Contract #: 04-0120F4
 Cty: SF/ALA Rte: 80 PM: 13.2/13.9
 File #: 69.25B

QUALITY ASSURANCE -- NON-CONFORMANCE REPORT

Report No: NCR-000976

Reference Description: Transverse Crack Discovered by QA on Lift 13AW Deck Panel Weld # DP3118-001-052

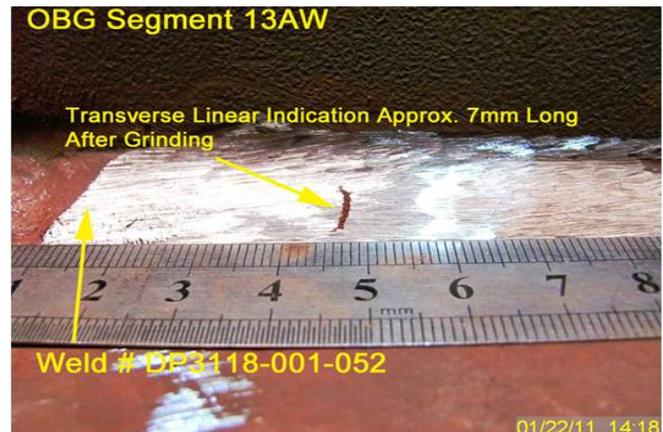
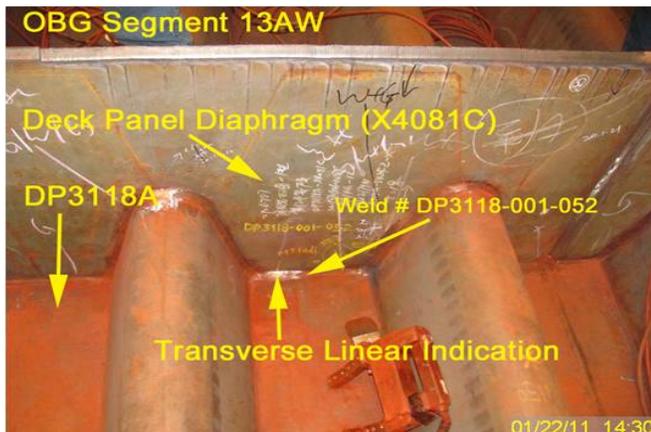
- One (1) Transverse crack measuring approximately 7 mm in length.
- The indication is clearly marked on the material near the weld.
- The weld is identified as DP3118-001-052.
- Weld is an 8mm Fillet Weld joining the Deck Panel Diaphragm To Deck Plate.
- Deck Panel Diaphragm is identified as X4081C (SPCM)
- Deck Plate is identified as DP3118A/PL3314A (SPCM).
- The weld is designated as Seismic Performance Critical Material (SPCM).
- OBG segment 13AW is located inside OBG Bay 14.
- ZPMC Quality Control Personnel have performed 100% Magnetic Particle Testing of these welds.

AWS D1.5 (02) Section 6.26.2 - "Welds that are subject to RT or MT in addition to visual inspection shall have no cracks..."

AWS D1.5 (02) Figure 6.8 – Specifies the maximum length of discontinuity allowed in an 8mm weld is approximately 3mm.

Reference Resolution: ZPMC has repaired the indication noted in the NCR and is providing NDT documentation after the repair to show the indication has been removed.

This proposed resolution is acceptable. The documentation received is sufficient and the Department concurs that Non-Conformance ZPMC-0935 is closed.

Reference Description: Transverse Crack Discovered by QA on Lift 13AW Deck Panel Weld #
 DP3118-001-052

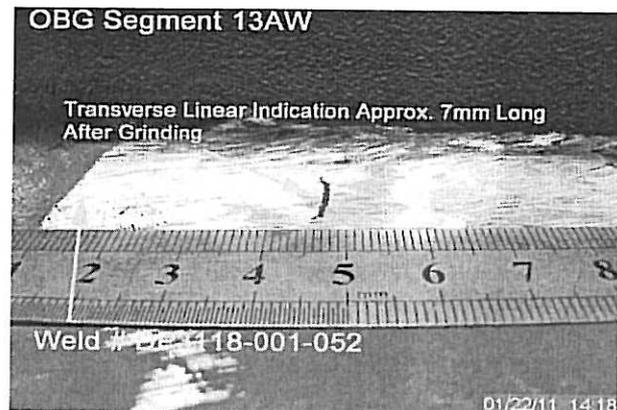
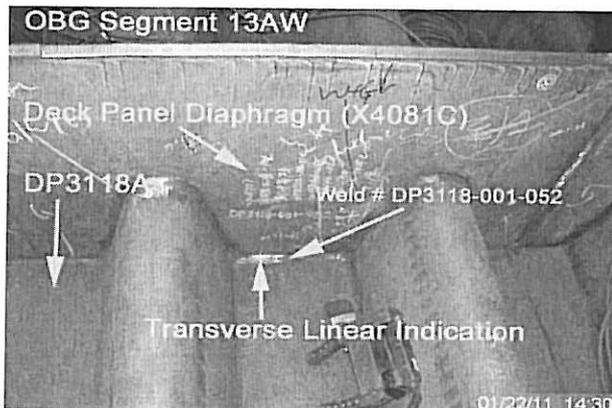
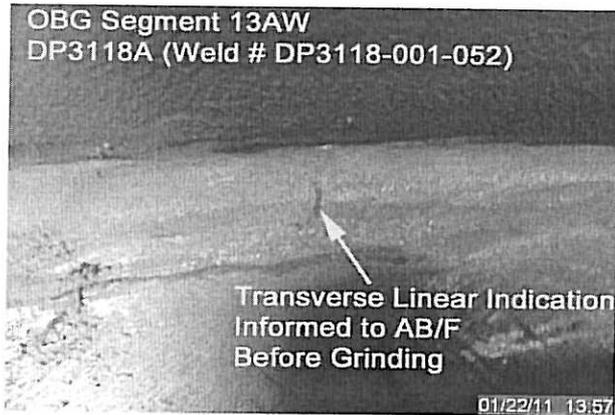
- One (1) Transverse crack measuring approximately 7 mm in length.
- The indication is clearly marked on the material near the weld.
- The weld is identified as DP3118-001-052.
- Weld is an 8mm Fillet Weld joining the Deck Panel Diaphragm To Deck Plate.
- Deck Panel Diaphragm is identified as X4081C (SPCM)
- Deck Plate is identified as DP3118A/PL3314A (SPCM).
- The weld is designated as Seismic Performance Critical Material (SPCM).
- OBG segment 13AW is located inside OBG Bay 14.
- ZPMC Quality Control Personnel have performed 100% Magnetic Particle Testing of these welds.

AWS D1.5 (02) Section 6.26.2 - "Welds that are subject to RT or MT in addition to visual inspection shall have no cracks..."

AWS D1.5 (02) Figure 6.8 – Specifies the maximum length of discontinuity allowed in an 8mm weld is approximately 3mm.

Contractor will repair the indication noted in the NCR and will provide the NDT report to prove the weld is acceptable after repairing. Contractor will monitor the inspector's performance. Disciplinary action will be taken if he misses indication continuously.

Contractor removed the weld indication. NDT report was provided showing the welds are acceptable. The inspector's performance was being monitored.
